ENVIRONMENTAL REVIEW TEAM REPORT

EXECUTIVE OFFICE PARK SOUTHINGTON, CONNECTICUT

Prepared by the King's Mark Environmental Review Team of the King's Mark Resource Conservation and Development Area, Inc.

Southington Conservation Commission

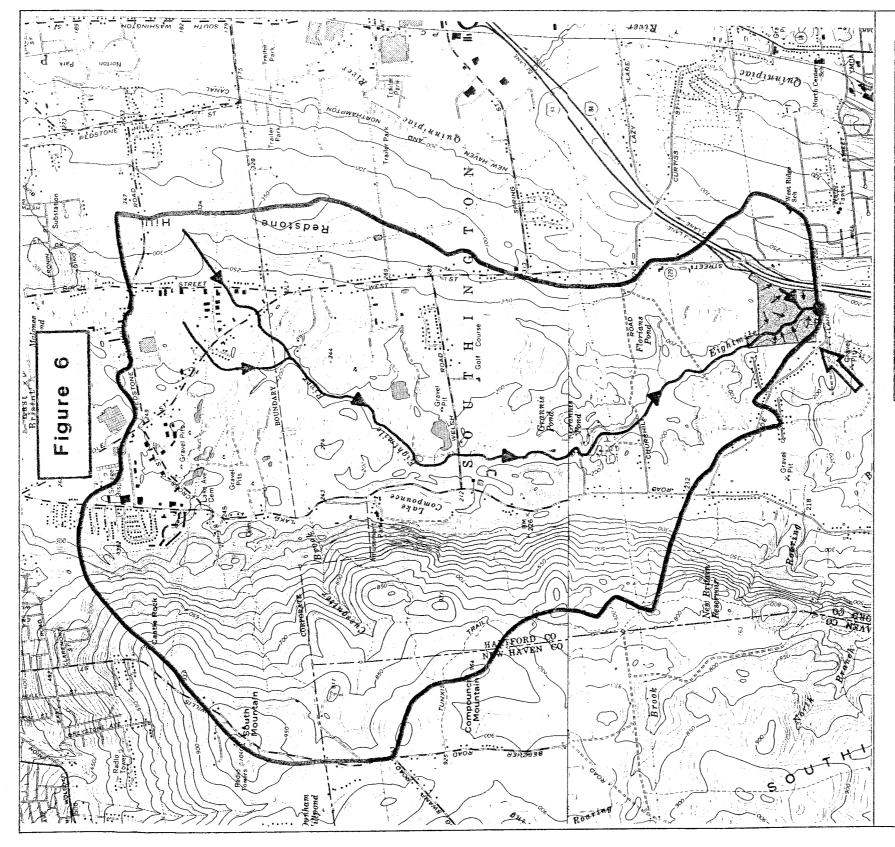
As shown in Figure 6, the drainage area for the Eightmile River to the point where it passes under Jude Lane encompasses an area of about 4,660 acres or 7.3 square miles. Based on this drainage area,

Since Southington has regulations that require postdevelopment flows not to exceed predevelopment flows from a particular site, each developer will need to determine the potential hydrologic effects of his/her development. As a result, it is encouraged that the applicant prepare a stormwater management plan, including pre- and postdevelopment runoff calculations. Once the plan is devised, it should be reviewed by appropriate town officials. Also, it is suggested that the applicant's engineer take a close look at all downstream culverts. Town officials stated on the review day that flooding has not been a problem in downstream areas of Eightmile River.

A likely solution for controlling postdevelopment flows would be the construction of detention pond(s). It is suggested that detention ponds be constructed on upland soils instead of wetland or flood plain soils since these soils have some intrinsic capacity for natural stormwater retention. Detention ponds on upland soils will minimize wetland impacts while providing the desired pond retention system. However, if detention ponds were placed on upland soils for the proposed development, it appears there would be a need for reducing the density of buildings and/or parking areas.

Figure 7, adapted from the FEMA map, identifies the flood prone areas within the study site.

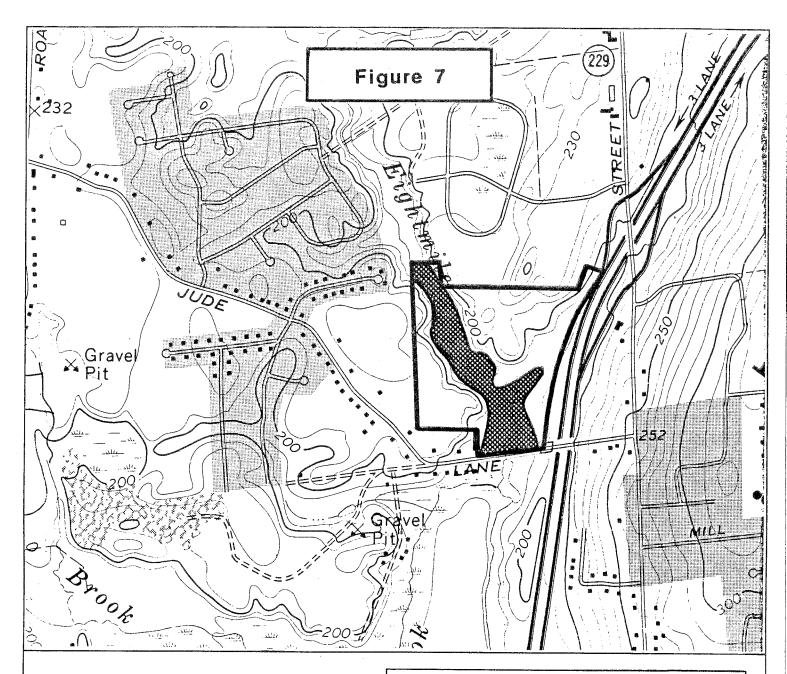
The generally flat topography in the flood plain makes this area very effective in storing water during periods of flooding. The flatness maximizes the available flood storage volume, while existing flood plain or wetland vegetation reduces flow velocities. For these reasons, filling in of flood plains or wetlands paralleling the River should be avoided if at all possible under any development scheme.

Any construction, (i.e., roads, buildings, etc.) occuring within the 100-year flood boundary will need to comply with all State and local regulations such as the State Building Code.
